PAVEMENT REPLACEMENT OVER SUM - I.R. 76 FROM S.L.M. 8.24 TO 10.00, SUM - 77 FROM S.L.M. 9.74 TO 11.54, AND SUM - 8 FROM S.L.M. 0.00 TO 1.75. COVERS THE "SOUTH LEG" AND "WEST LEG", INCLUDES REHABILITATION OF SEVERAL STRUCTURES IN THE CITY OF AKRON, SUMMIT COUNTY, OHIO.

BU-39 - TRAFFIC CONTROL

AKRON BELTWAY JV
BU - 39
Traffic Control
CENTRAL INTERCHANGE AND SR-8
RFC PLANS
FEBRUARY 22ND, 2022

2026-03-24 - BU-39 - RECORD DRAWING PLANS

ITEM 630 - SIGN SUPPORT ASSEMBLY, BARRIER MOUNTED, AS PER PLAN

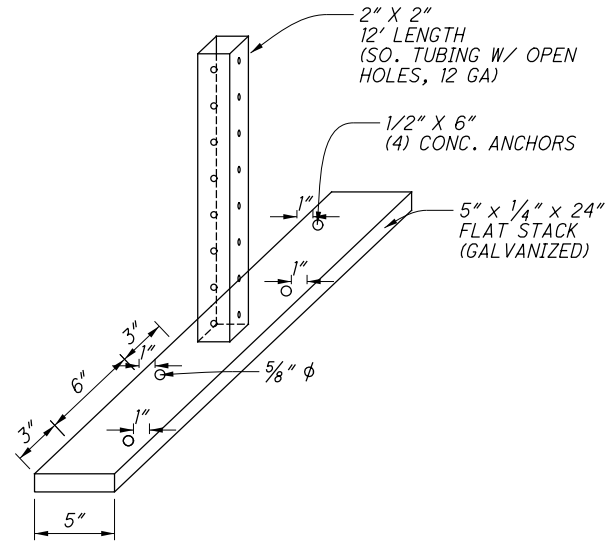
ISSUE RECORD: BU-39 TRAFFIC			CALCULATED EEB	CHECKED EAK	TRAFFIC CONTROL NOTES
NO.	DATE	DESCRIPTION			
AB-1	3/20/26	ITEM 630 - AS PER PLAN DESIGN CHANGE			
2026-03-24 - BU-39 - RECORD DRAWING PLANS					
					SUM-76 / 77 / 8 8.24 / 9.74 / 0.00
					2 72

THE CONTRACTOR SHALL USE CONCRETE BARRIER MOUNTED SIGN SUPPORTS, AS PER THE DETAIL BELOW.

THE ABOVE WORK SHALL BE PAID FOR UNDER ITEM 630 - SIGN SUPPORT ASSMBLY, BARRIER MOUNTED, AS PER PLAN AND SHALL INCLUDE ALL LABOR, BRACKETS AND MATERIALS REQUIRED TO COMPLETE THIS WORK.

SIGN & PAVEMENT MARKING PLAN - SR-8

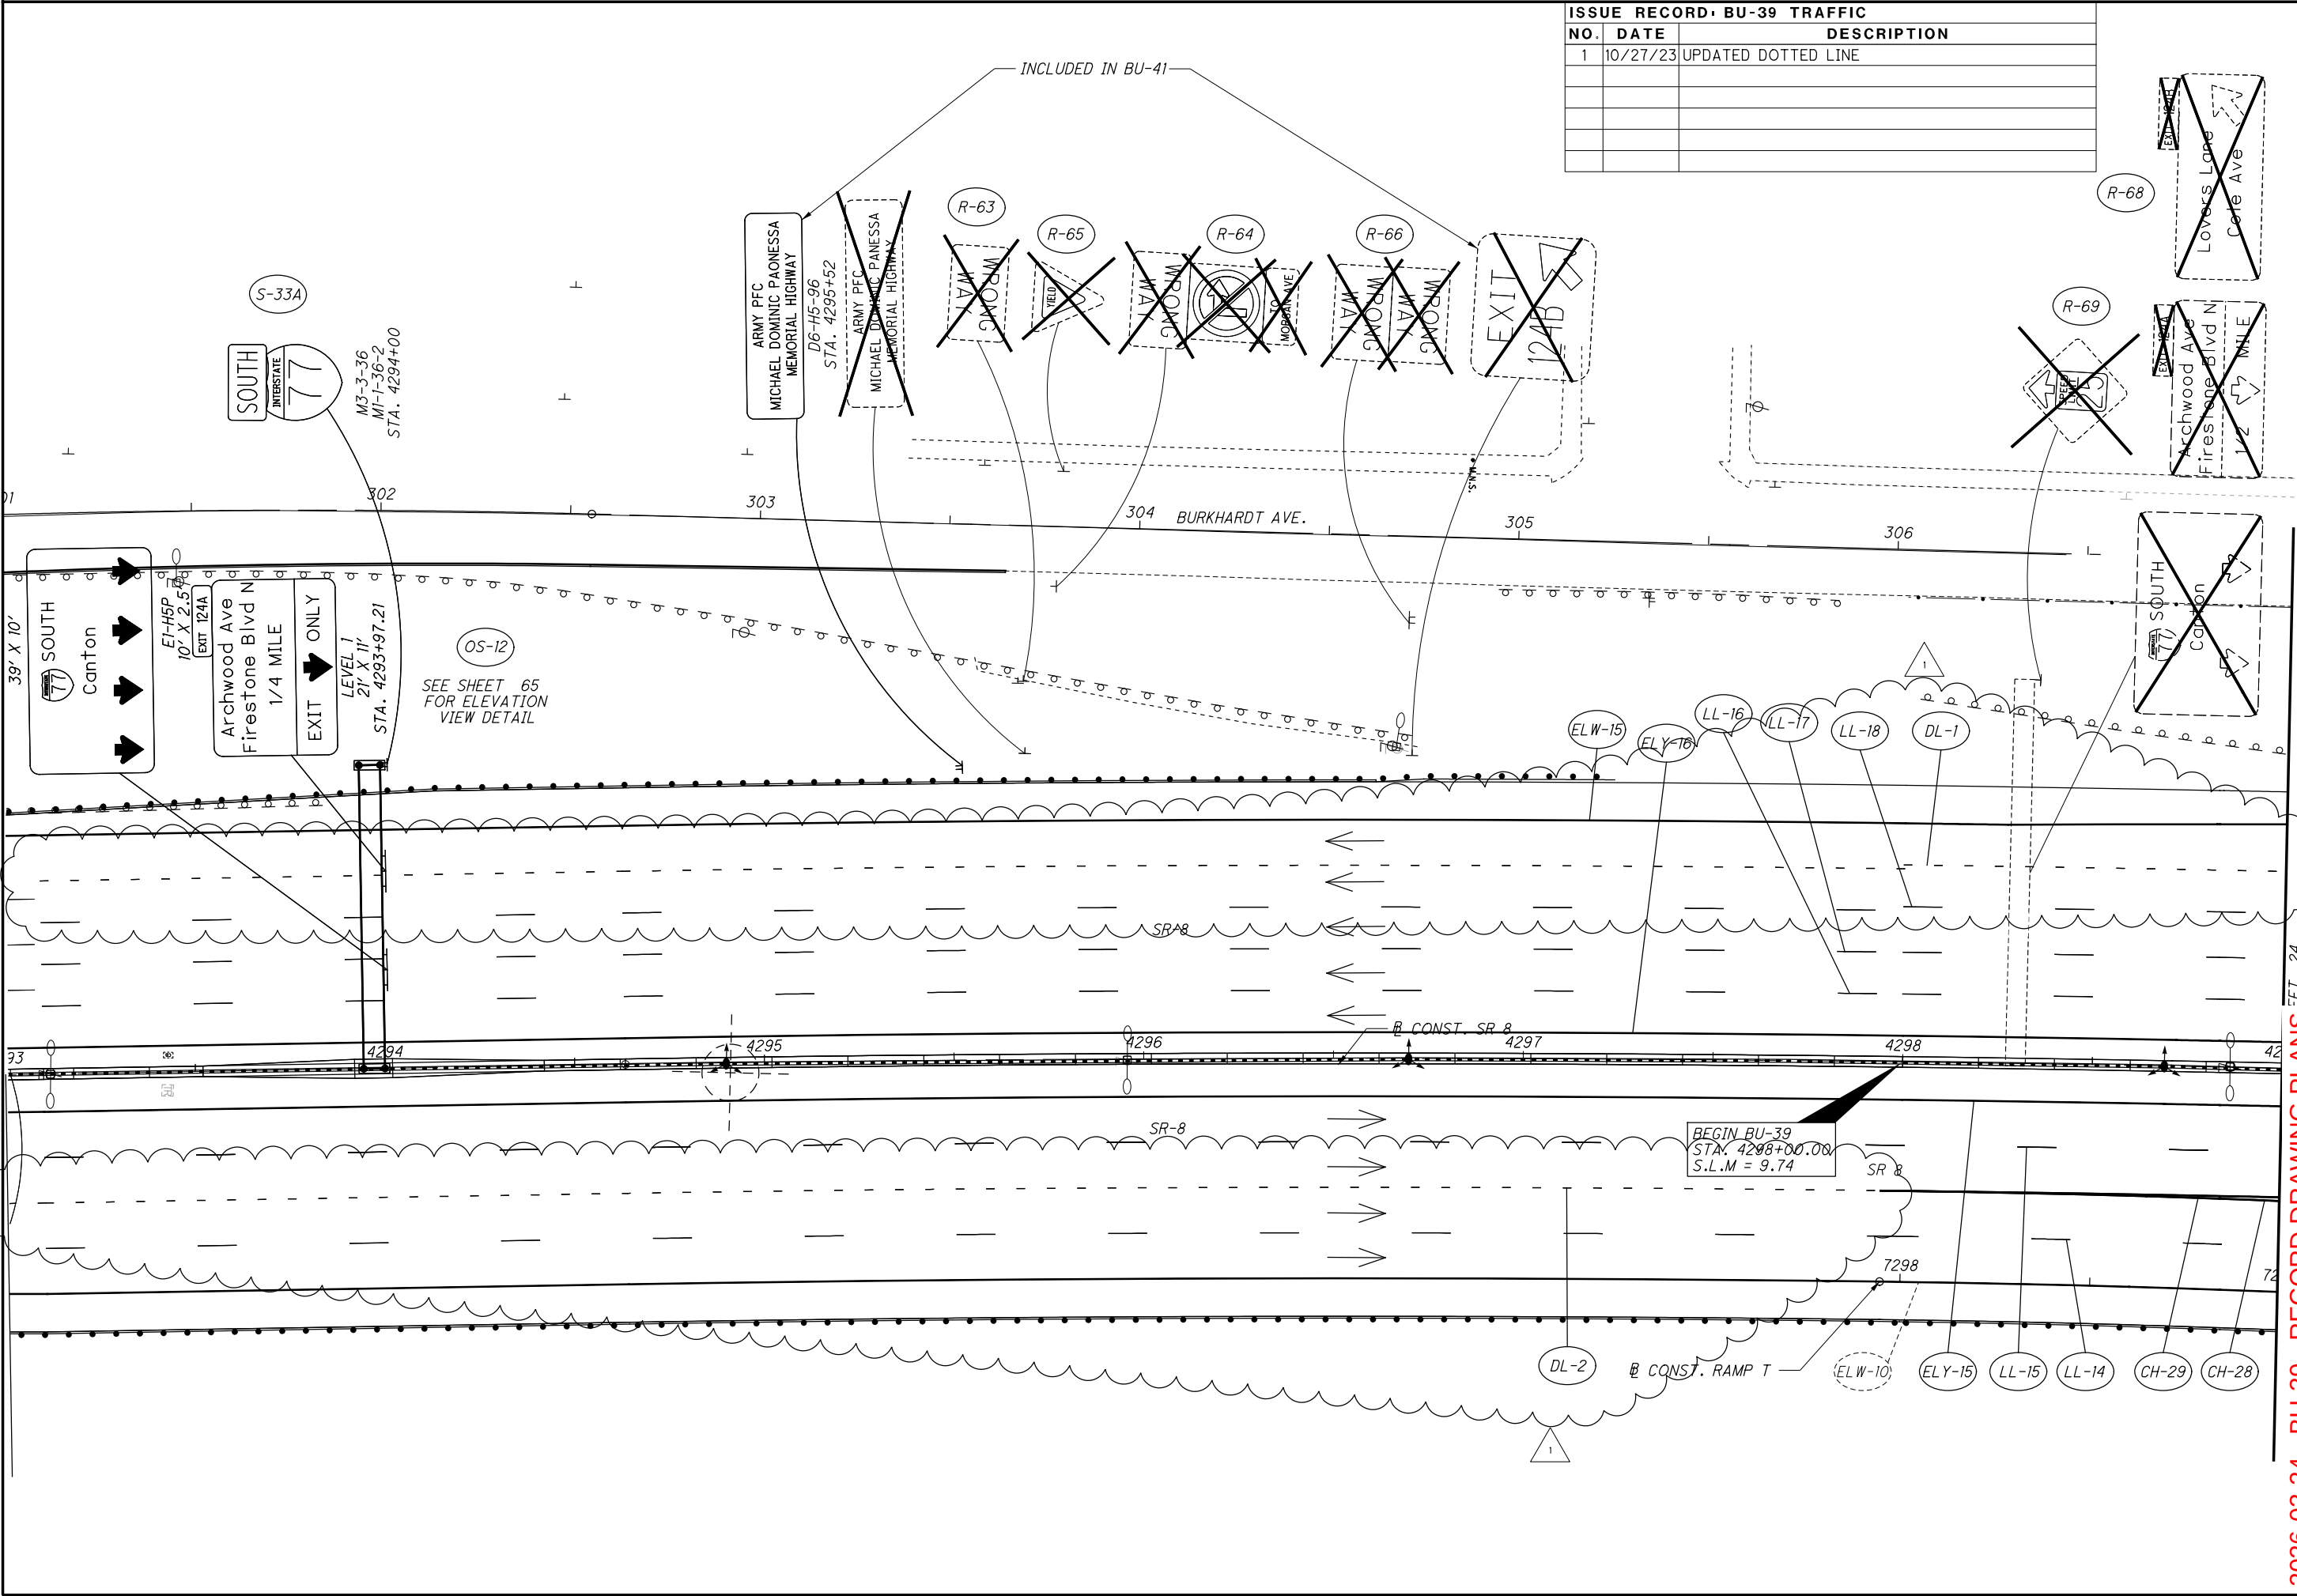
ISSUE RECORD: BU-39 TRAFFIC		
NO.	DATE	DESCRIPTION
1	10/27/23	UPDATED DOTTED LINE

OS-3
STA. 492+68 I.R. 76 EASTBOUND
EXISTING TYPE TC-7.65, DESIGN 8, 5' BOX, 106'-10" SPAN

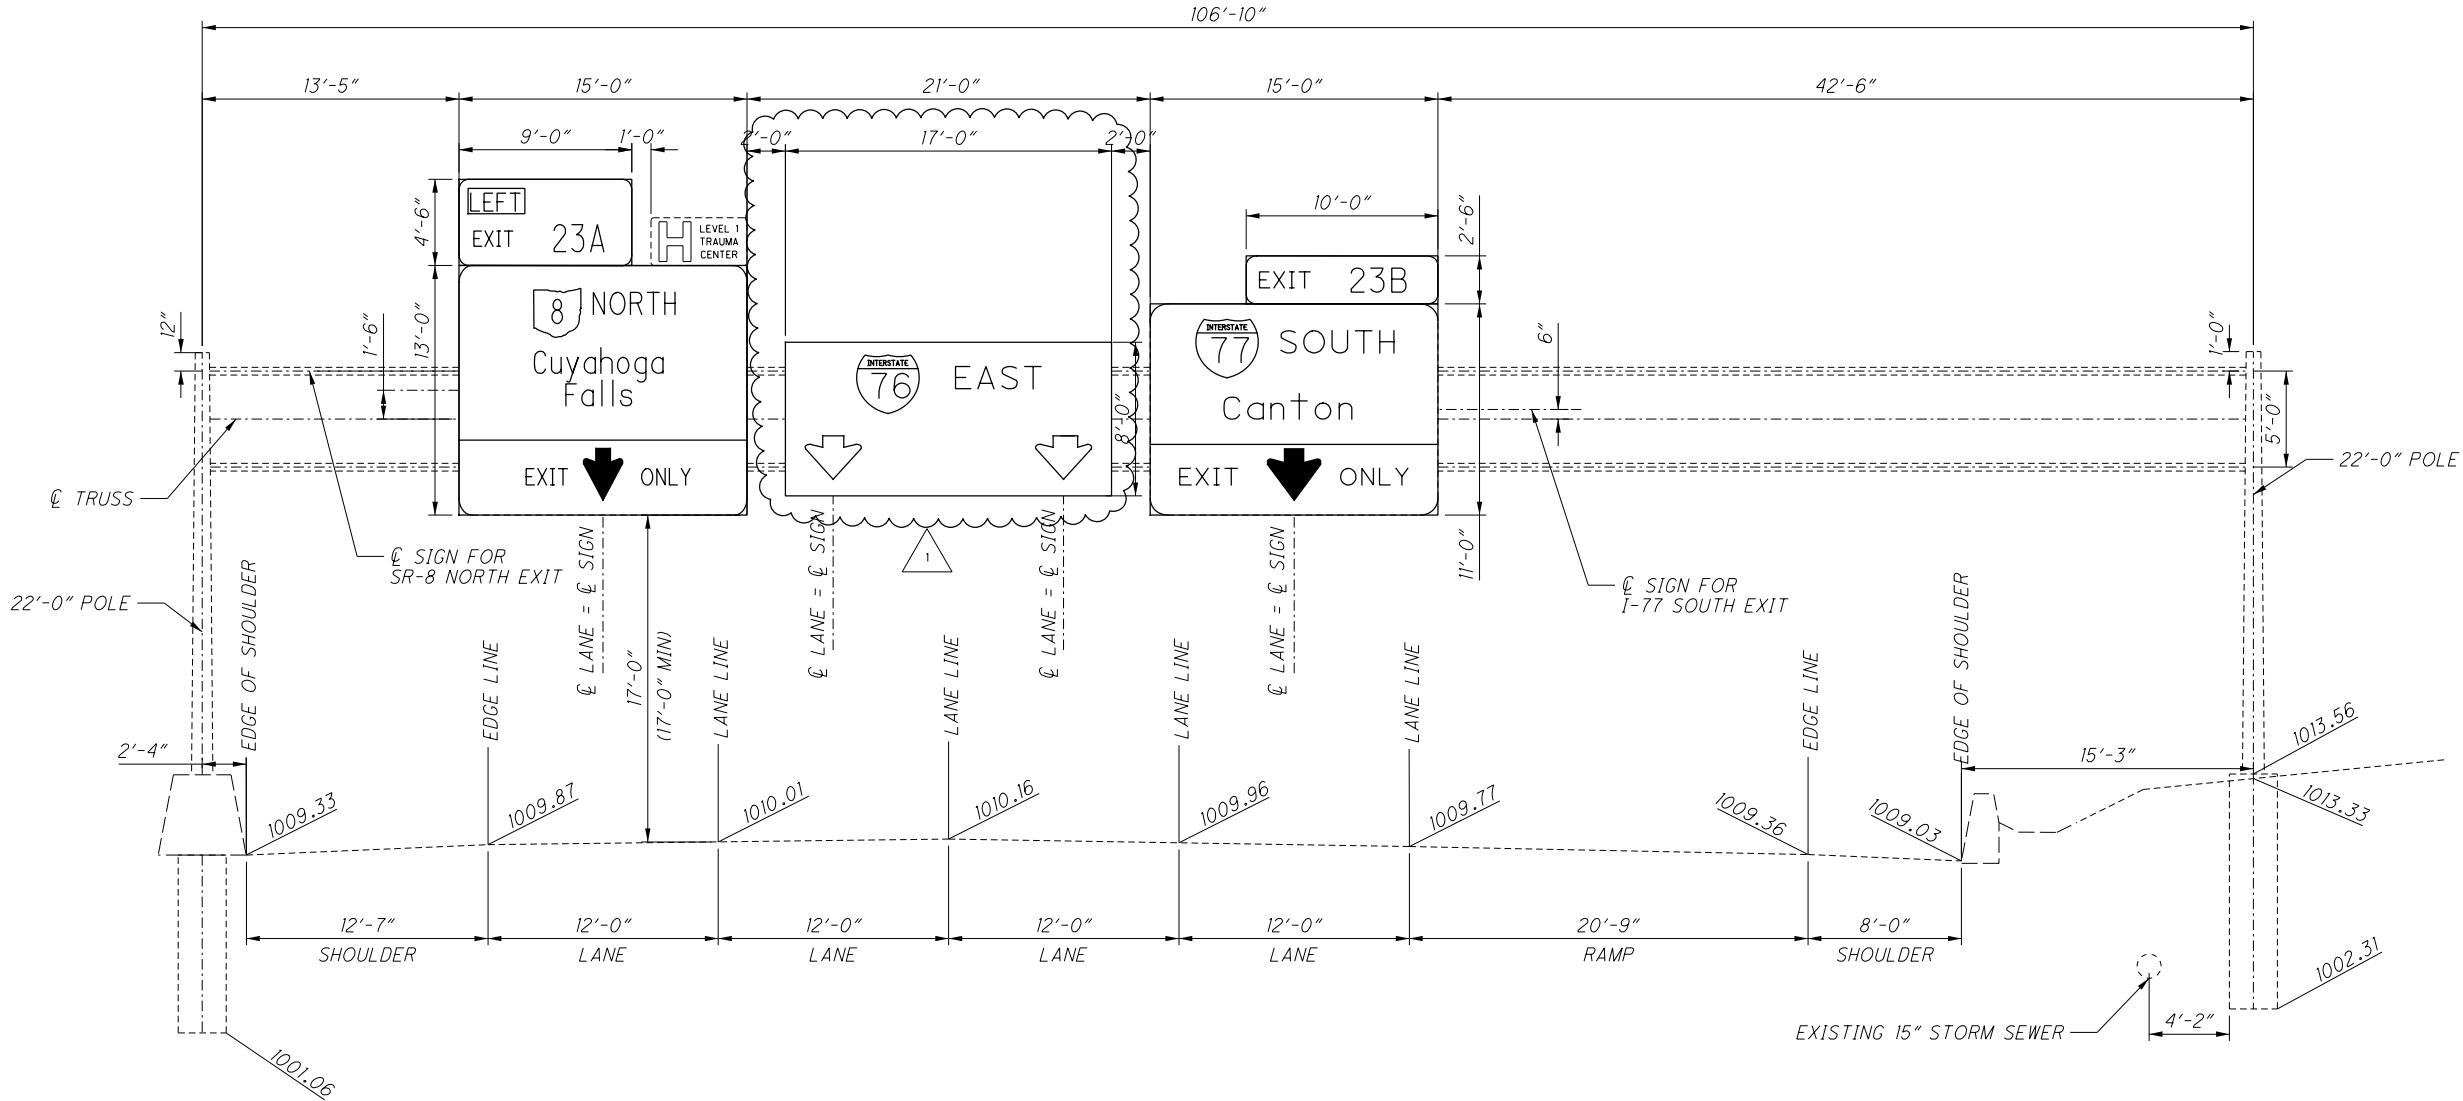
ISSUE RECORD - BU-39 TRAFFIC		
NO.	DATE	DESCRIPTION
1	10/27/23	ADDED SIGN

OS-15
STA. 4330+10.00 S.R. 8 SOUTHBOUND
LOOKING SOUTH
TYPE TC-15.116, DESIGN 2, 82' SPAN

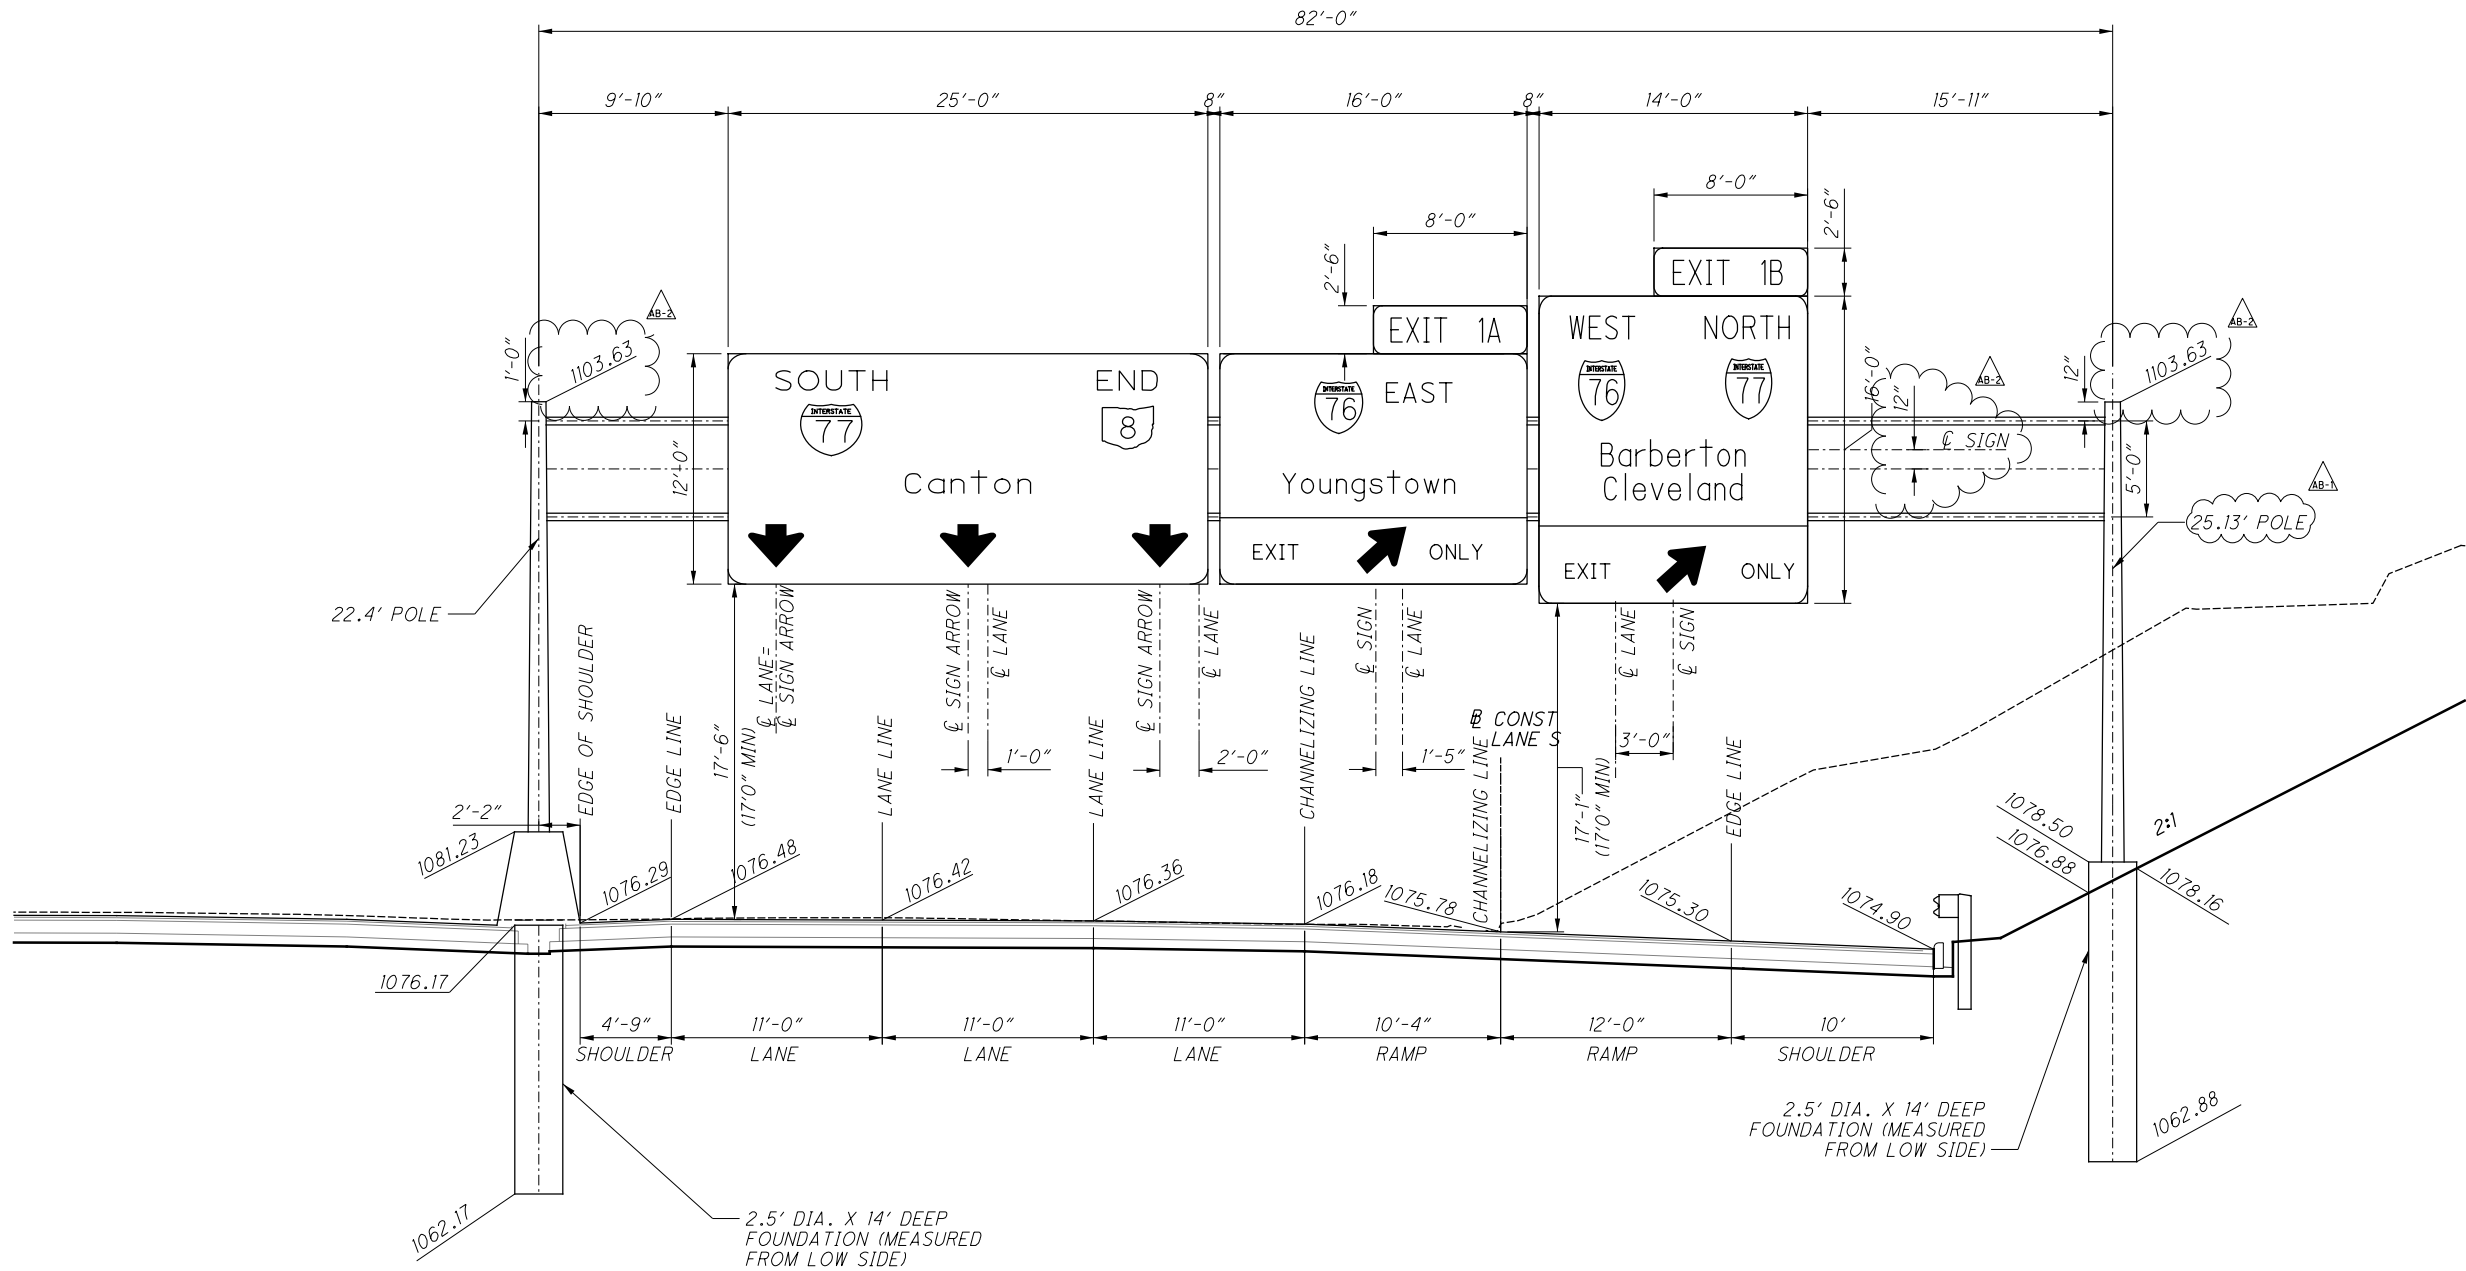
ISSUE RECORD - BU-39 TRAFFIC		
NO.	DATE	DESCRIPTION
AB-1	11/8/2024	CHANGED ELEVATION TO RIGHT POLE
AB-2	11/12/24	ADDED DIMENSION/ELEVATIONS

* MEASUREMENT IS AN ESTIMATE. FIELD ADJUST TO ACHIEVE AT LEAST THE REQUIRED 17'-0" MINIMUM VERTICAL CLEARANCE REQUIREMENT
